Arbor Heights
 Recommendation Meeting
 4220 SW 100th St, Seattle, WA

RESPONSE TO EDG

Arbor Heights
4220 SW 100th Street
SDCI # 3025192

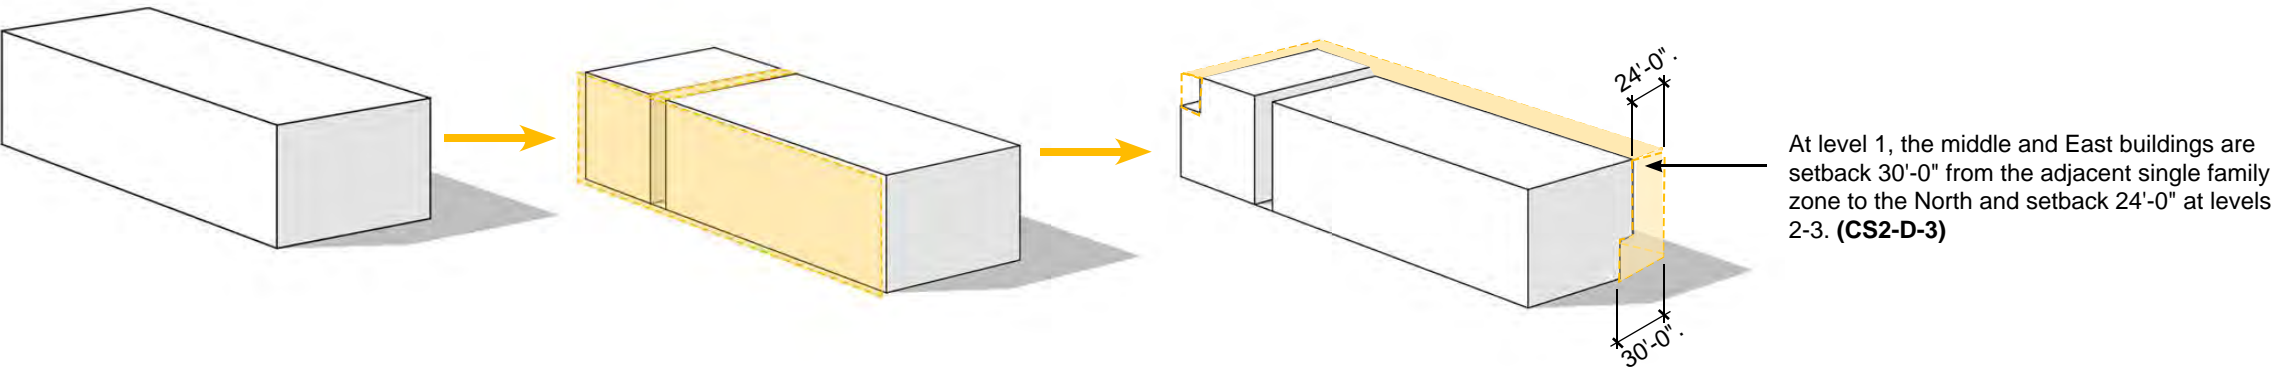
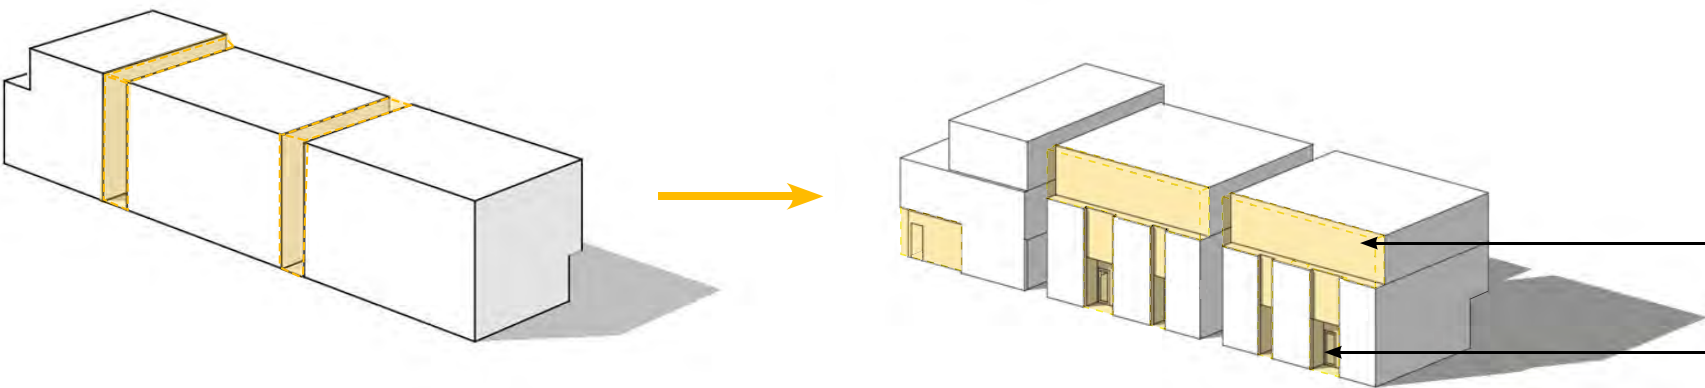
a.i The design concept should be further reduced from two masses to three distinct masses as contemplated in Scheme 2 that harken to the existing pattern and scale of the immediate context of single family-zoned properties. **(CS2-D, CS3-A)**

a.i Approved Scheme 3 has been developed further and has been reduced from two mass to three mass as a response to the existing character of the single-family neighborhood. The developed masses fit well within the existing rhythm and urban pattern. The building is set back from the North property lot to create a buffer from the single-family residence and maintain privacy for the neighboring units. To maintain the scale along California Ave SW, the West building mass at level 3 is stepped back to create a transition from the neighborhood commercial zone to single-family zone. **(CS2-D-3)** Penthouses are not proposed for the accessible roof decks of the middle and East building to reduce the scale of the building. **(CS3-A)**

At level 1, the middle and East buildings are setback 30'-0" from the adjacent single family zone to the North and setback 24'-0" at levels 2-3. **(CS2-D-3)**

At level 3, the mass is set back from the street to reduce the scale to fit in with the context. **(CS3-A)**

The residential entries along SW 100th St are recessed and create a cedar wood threshold to break down the scale of the facade and to create a better transition from public to private space.

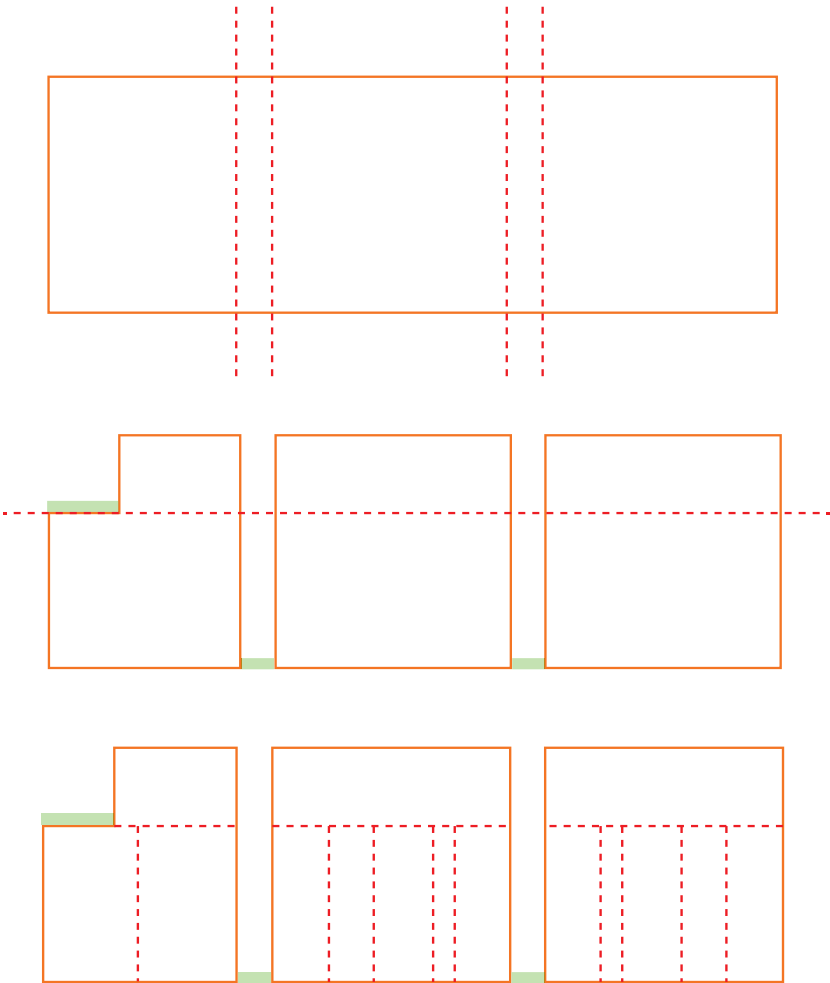
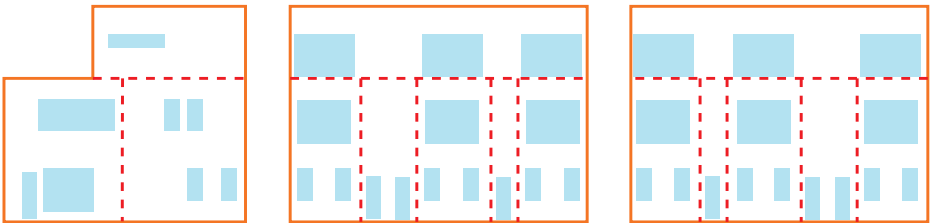
a.ii It is imperative that each building mass be scaled down appropriately to better respond to the surrounding residential context. The Board looks forward to reviewing the next design iteration which should be comprised of secondary architectural elements, minor massing moves, materials, glazing, etc. That successfully achieve this design direction. Initial Board feedback concerning the conceptual perspective illustrated in the design packet (pg. 47) was that the amount of glazing applied to the buildings' exterior facades was an inappropriate response to this guidance.(CS3-A, DC2-A, DC2-B, DC2-C, DC2-D)

a.ii The massings are broken down using well-composed openings and varying balconies. Facades are modulated through the use of high-quality, durable materials and various setbacks. Materials help enhance the simple massing forms and overall architectural character within the neighborhood. At street level, the human scale is achieved by using recessed entries, steel canopies, and appropriately scaled windows. (DC2-C-2) Larger windows are utilized at the corner of the West building to express the Live-Work unit and create a vibrant street front. (DC2-D-1) The conceptual diagram to the left explains how we are setting back level 3 to express a two story mass at the street to better respect the neighboring context. (DC2-C-3, DC2-A-2) These two story masses along the street are further broken down by recessing the entries to create a successful rhythm and scale that is appropriately scaled for residents.

The massing is broken into 3 buildings vertically to fit in the context of the single family zone.

Each mass is horizontally broken down by terracing level 3 to express a two story mass at the street.(DC2-A-2)

Each mass is further broken down with recessed entries and material transitions to respect the neighborhood scale. (CS3-A-1, DC2-B-1)

The residential units at level 1 have smaller windows with recessed entries to maintain privacy. Larger windows express the Live-Work unit on the corner. (DC2-D-1)

High quality materials, canopies, and balconies are well composed to add depth and visual interest to the facade. (DC2-C-1)

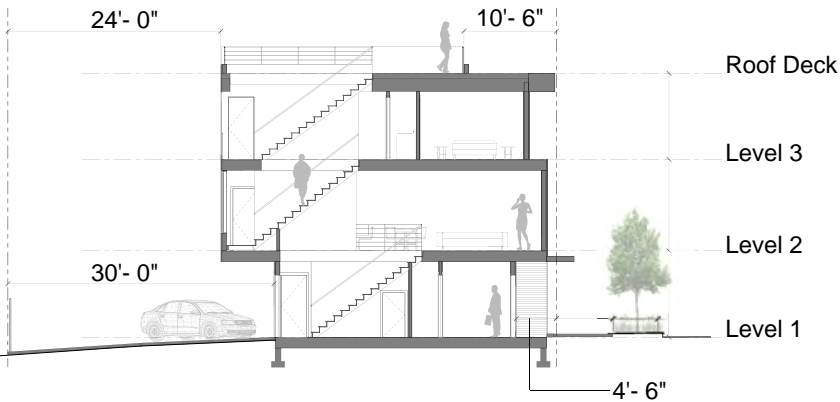
a.iii The Board emphasized that special attention be applied to the entry sequencing of the townhouse units' entrances at grade. A design that creates a strong street wall, especially for the residential units abutting Southwest 100th Street, was strongly discouraged by the Board. (CS3-A, PL3-A, PL3-B, see departure #3)

a.iv In response to public concerns pertaining to roof forms (pitched versus flat), the Board discussed roof forms. The Board stated that the presented height of the proposed flat-roofed massing forms is respectful to the allowable height limits of existing residential structures within the neighborhood and will be complementary to the surrounding varied architectural style of neighboring buildings. (CS3-A-1)

a.iii The townhouse entries along California Ave SW and SW 100th St are either one step above or below the sidewalk grade, as requested in departure #3. The overall building height is reduced by allowing these entries to be close to the sidewalk grade and make the entries more accessible to residents. These entries are also recessed 4'-6" from the South property line to provide privacy and security for residents. Each entry is well-lit with black metal soffit lighting fixtures and black metal wall-mounted lighting fixtures shown on the lighting plan and in the image to the left. (PL3-B-2)

Each residential entrance is designed at human scale thru the use of metal canopies with cedar wood soffits, appropriately scaled materials and landscaping. A cedar wood decking threshold is proposed at level 1 for the residential entries to create a better transition from the public sidewalk to the private residences. (PL3-A-1-D, PL3-A-2, PL3-B-2)

a.iv In response to the Board, the proposed design of each building utilizes a flat roof by eliminating the stair penthouses to maintain its relationship with the existing structures within the neighborhood. These flat roofs reduce the overall height to complement the surrounding context. Additionally, the accessible roof deck for the middle and East buildings is setback 10'-6" from the South property line, see the section diagram to the right. (CS3-A-1)
